MIL-B-81935/5B
 AMENDMENT 1
 19 April 1991

MILITARY SPECIFICATION SHEET

BEARING, PLAIN, ROD END, SELF-ALIGNING, SELF-LUBRICATING,
 NARROW, INTERNALLY THREADED, -65°F to +325°F

This amendment forms a part of MIL-B-81935/5B, dated 1 June 1987 and is approved for use by all Departments and Agencies of the Department of Defense.

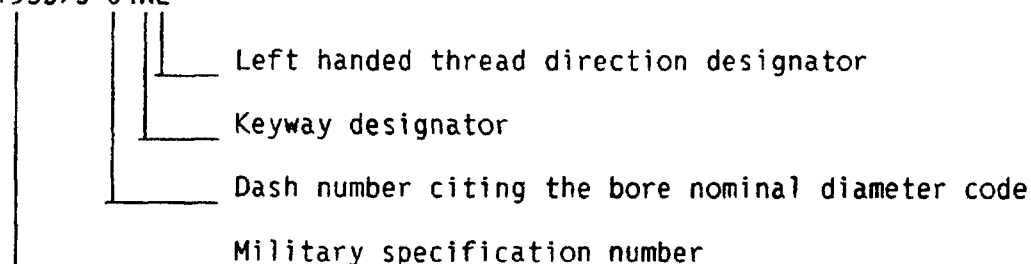
Substitute the table containing terminal thread, K, and P dimensions with the following table:

Dash No.	Terminal Thread	K +.005	P +.005
3 & 4	1/4 -28UNJF-3A	.062	.110
5	5/16-24UNJF-3A	.062	.110
6	3/8 -24UNJF-3A	.093	.110
7	7/16-20UNJF-3A	.093	.110
8	1/2 -20UNJF-3A	.093	.110
10	5/8 -18UNJF-3A	.125	.110
12	3/4 -16UNJF-3A	.125	.110
14	7/8 -14UNJF-3A	.156	.110
16	1 -12UNJF-3A	.156	.110
